## TECHNICAL MEMORANDUM

### RESPONSES TO HARDEN / TOWNSHIP OF PUSLINCH REVIEW COMMENTS – PROPOSED CBM ABERFOYLE SOUTH LAKE PIT

The table below provides WSP's responses to review comments made by Harden Environmental Services Ltd. (Harden) on February 7, 2024 and received by MHBC Planning from the Township of Puslinch on April 29, 2024 related to the ARA licence application for the proposed CBM Aberfoyle South Lake Pit.

**Figure 1: Numerical simulation results predicting an area of post-rehabilitation groundwater uplift, which could create minor flooding in during seasonal periods of a high water table.**

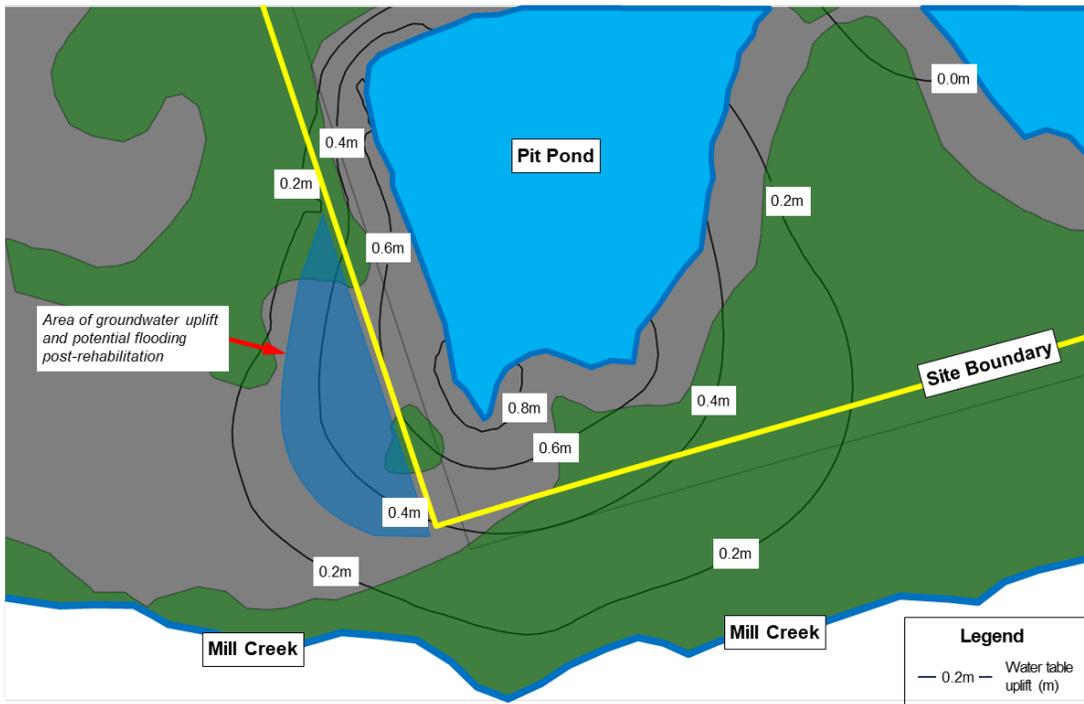
Numerical modelling simulations predict post-rehabilitation groundwater uplift at the site of approximately 0.6 m to occur immediately southwest of the proposed pit pond beyond the property limits, as shown on Figure 1. While the steady state groundwater level in this area is predicted to be below the ground surface, when seasonal variability is considered (approximately +/- 0.3 m annually at nearby MW18-01B) there is a potential for occasional flooding to occur on adjacent low lying lands during periods of high groundwater levels (e.g. during the spring freshet).

To address this potential impact, the installation of a tile drain is proposed in this area as a mitigation measure, to reduce the risk of occasional flooding on the neighbouring property, as shown on Figure 2. The tile drain would be installed in the setback area, between the pit pond to the east and the licence / property limit to the west.
